NEW BRIGHTON PLANNING COMMISSION
REGULAR MEETING

PLANNING REPORT

DATE: January 10, 2013
CASE: LP2013-001
SUBJECT: Site Plan for 850 County Road D W
APPLICANT: Andrew Wahl on behalf of Dental Property, LLC

to: Janice Gundlach, City Planner
from: Craig Schlichting, Civil Engineer II
subject: Village Orthodontics
date: January 9, 2013

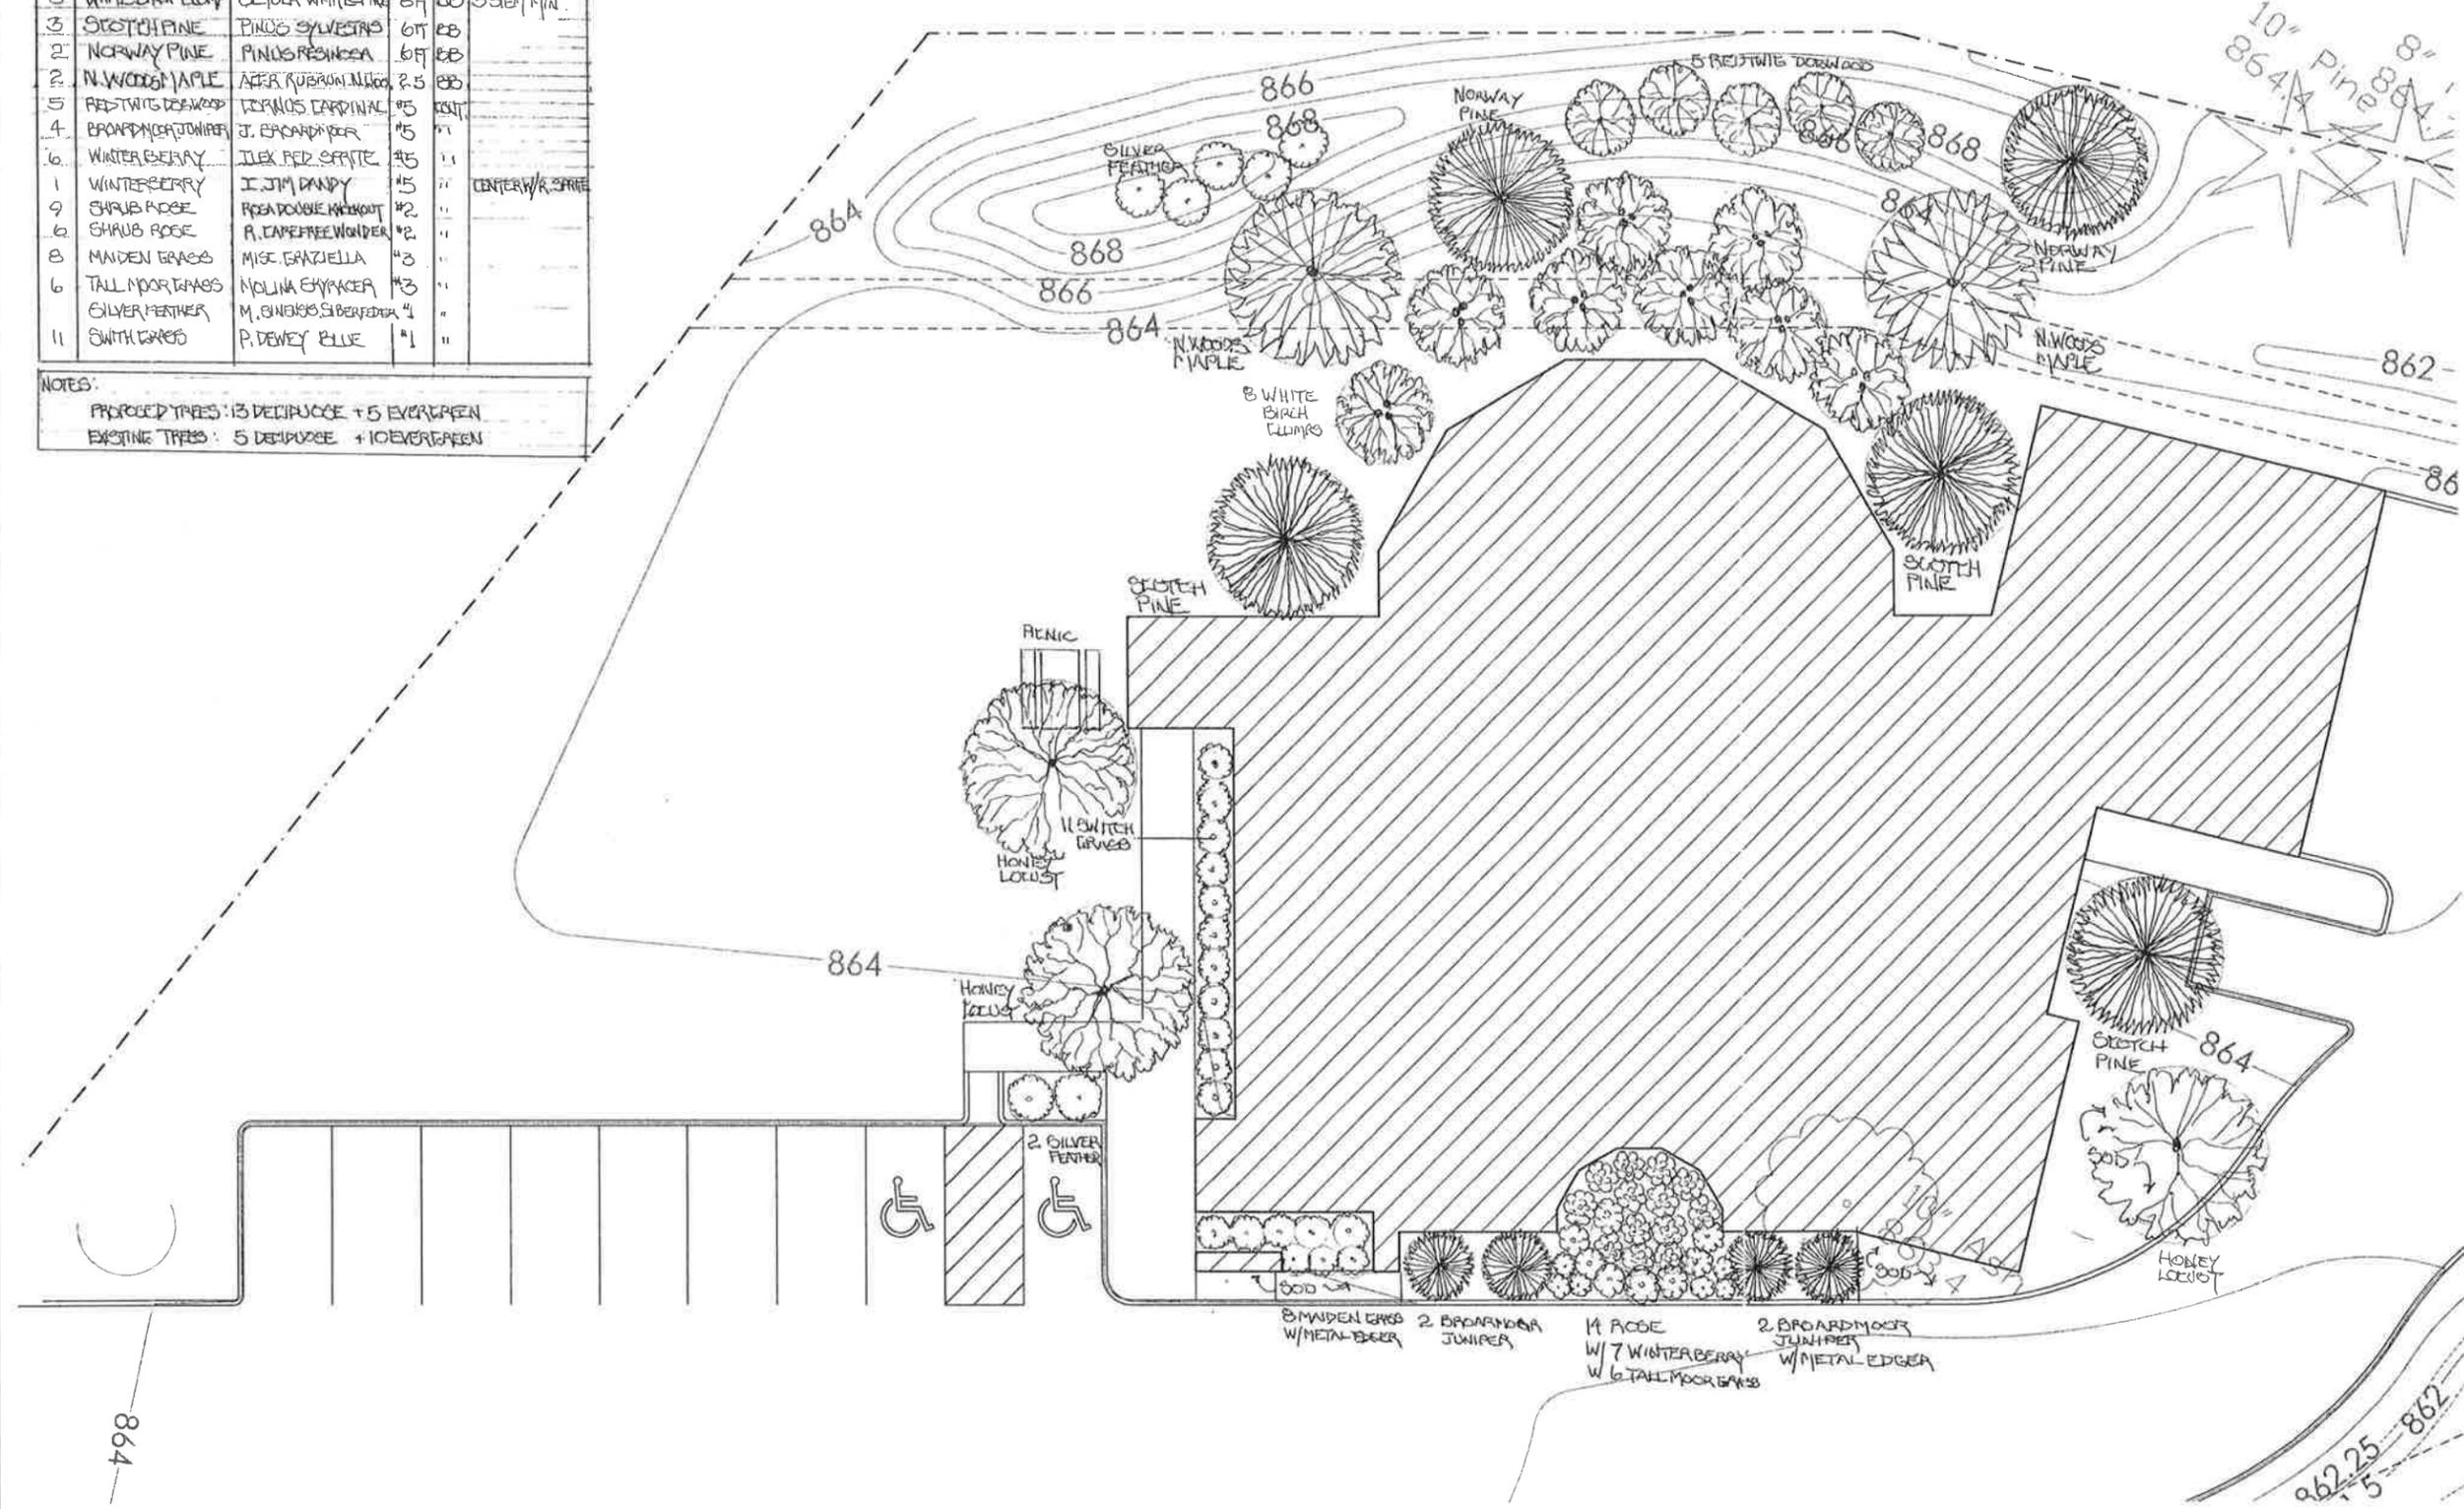
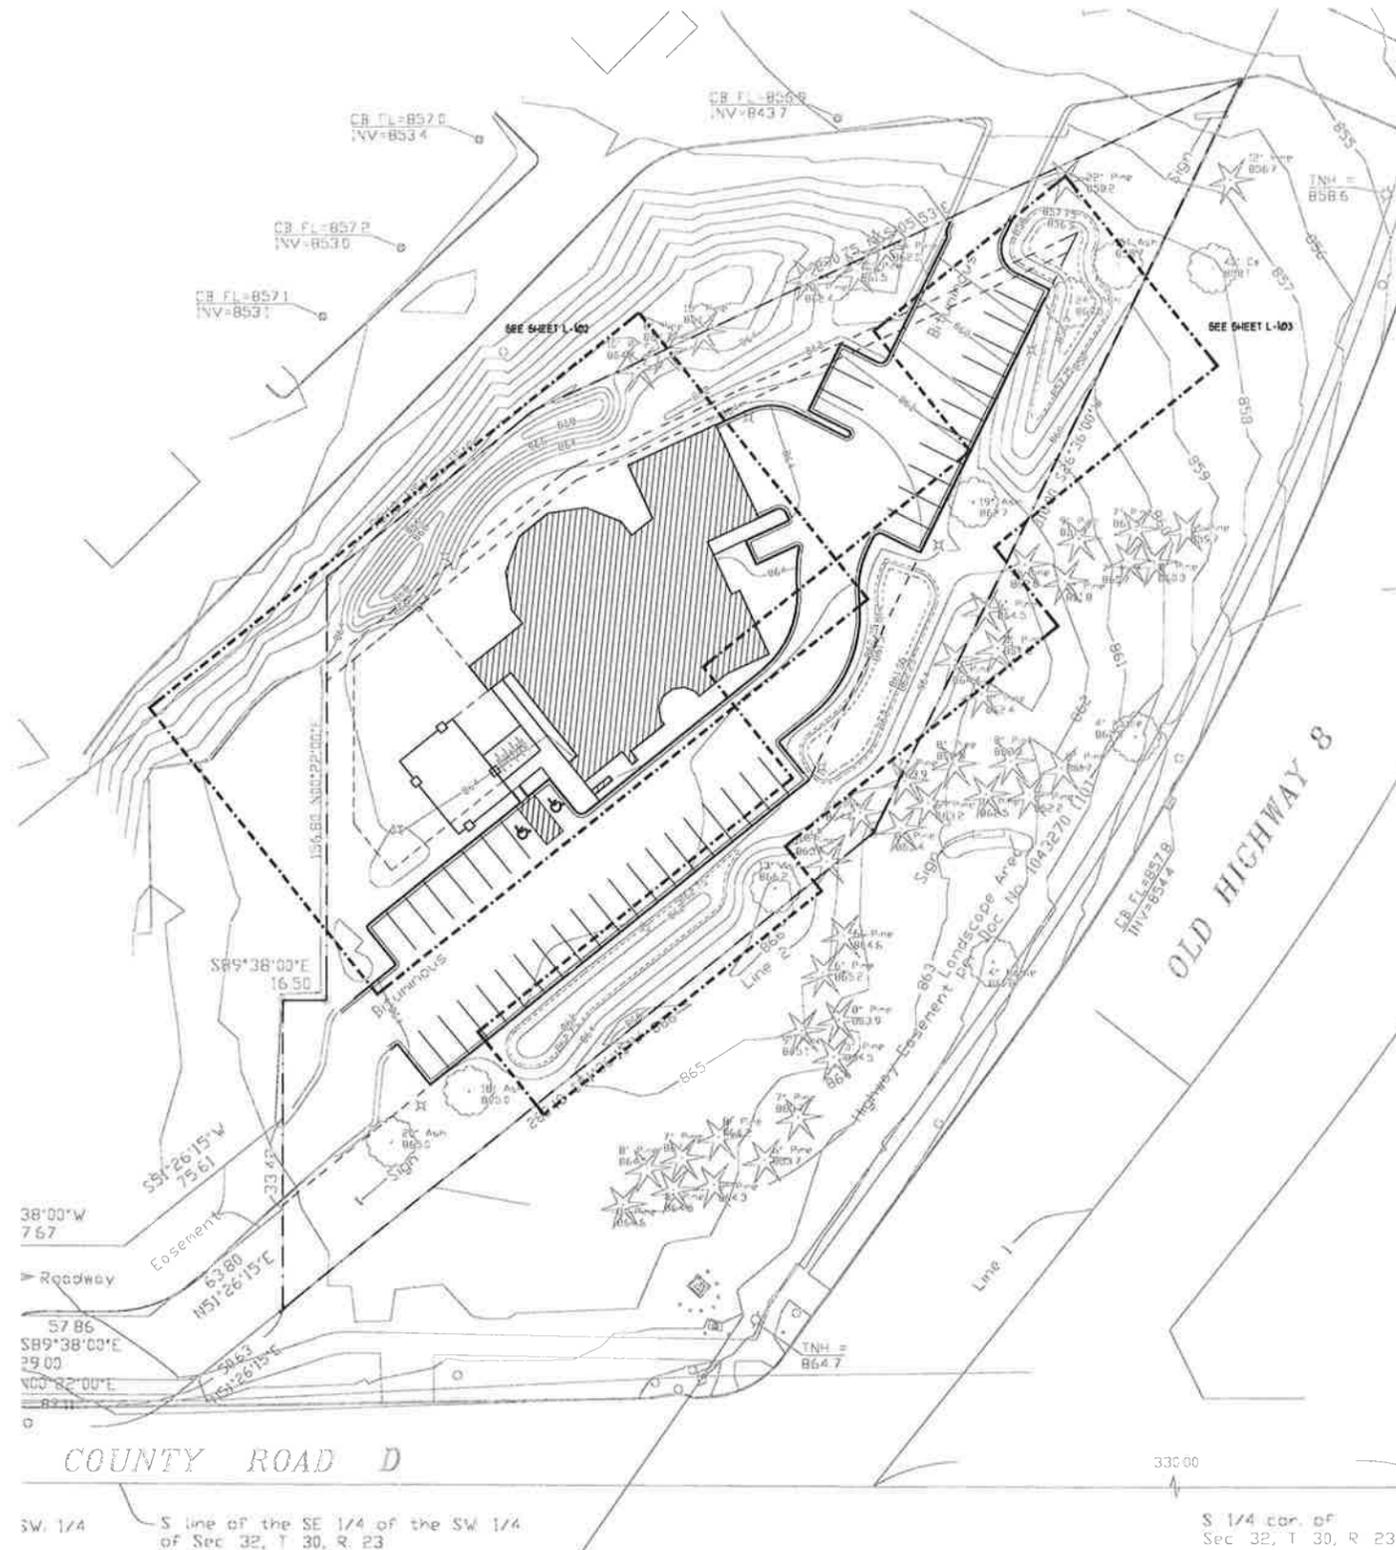
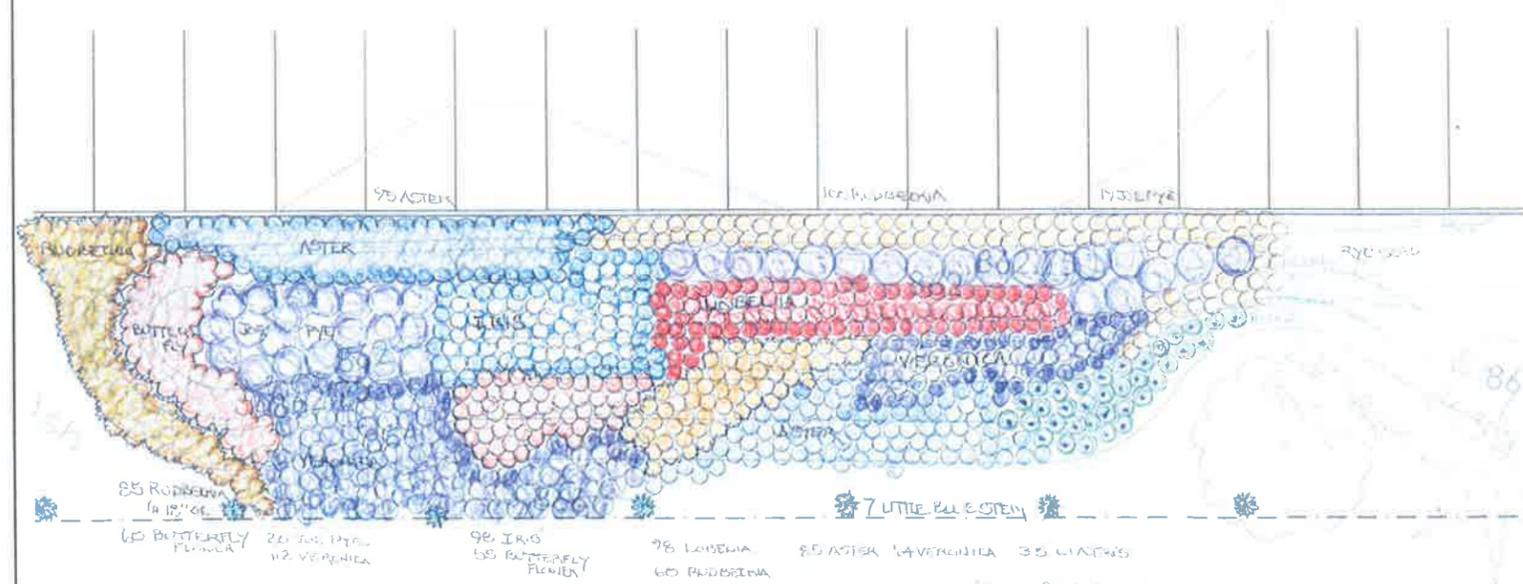
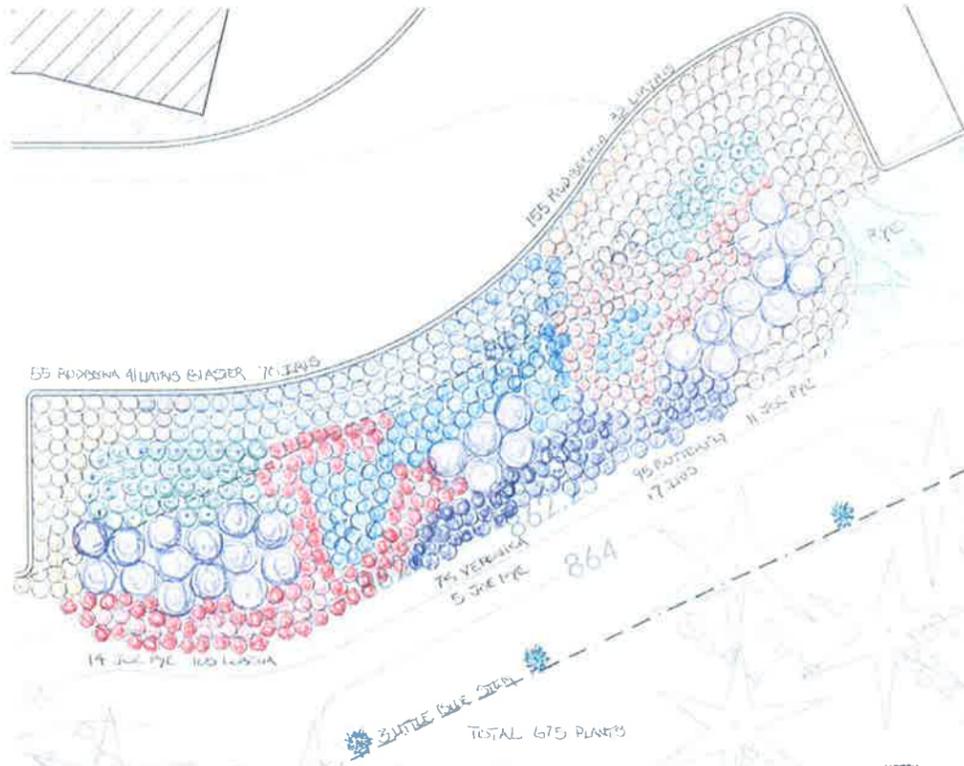
City staff has reviewed the proposed Landscaping Plan against the landscaping requirements of Section 8-010 (2) (C-G). In summary, staff offers the following comments with regard to the proposed Landscape Plan meeting the minimum requirements:

- 33 evergreen and 3 deciduous trees are proposed to be preserved within the boulevard area, meeting the requirement of one coniferous and one deciduous tree per lot to be planted within the boulevard.

- Less than 100 parking stalls are proposed, not requiring any raised parking lot islands.
- The applicant has provided heightened screening to the residential uses to the north by proposing a berm approximately 6' in height and landscaping the berm. Additionally, preserved pine trees will add to this screening.

- In addition to meeting the minimum landscaping requirements of Chapter 8, the applicant is providing three heavily-planted rain gardens to meet the watershed district standards. These rain gardens contain an additional 2,505 plantings, albeit seedlings, which will still provide additional landscaping interest to the property.

A2 SITE LIGHTING PLAN
AS161 1" = 30'-0"

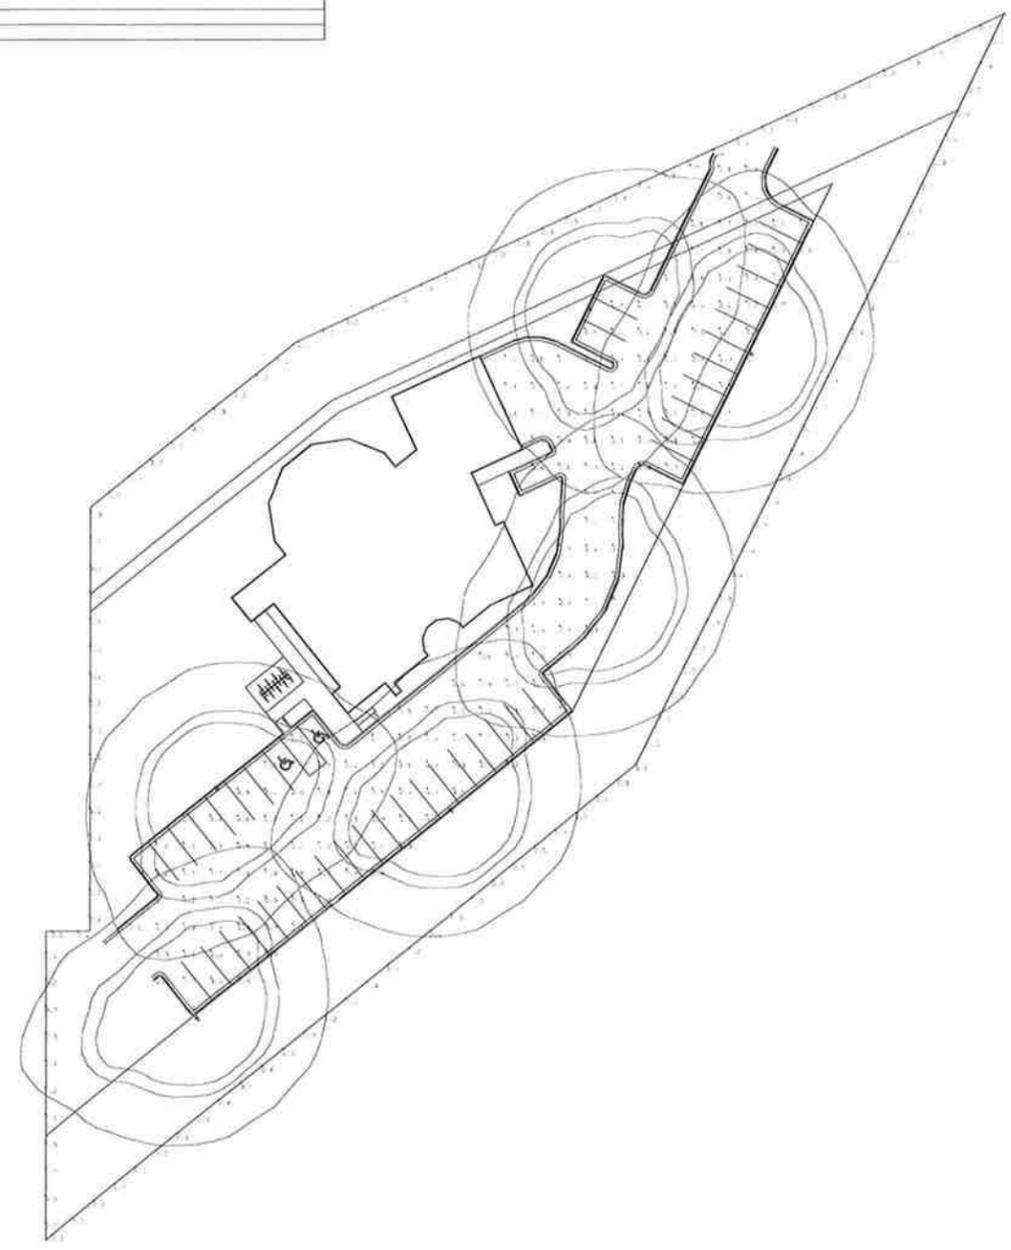
The applicant has provided a Lighting Plan for the pedestal lighting to be implemented in the surface parking lot. Zoning Code Section 11-010 (6) states that site illumination shall not exceed 0.4 foot-candles at ground level when measured at an adjoining residential property. The Lighting Plan illustrated nearly full compliance with the standard. There is one small location where the foot-candle measurement exceeds 0.4 at 0.5. However, this is located adjacent to the shared driveway access and when extrapolated to the other side of the driveway, the foot-candle maximum is less than 0.4, meeting the standard.

No building mounted lights have been incorporated into the plan nor have fixture details been provided. Zoning Code Section 11-010 (6) requires fixtures be directed downward and installed such that direct light isn't detectable at the property boundary. Staff is recommending a condition of approval that all site lighting comply with Zoning Code Section 11-010 (6). Being the size of the site and the proximity of residentially used property, staff finds compliance with these standards should not be burdensome.
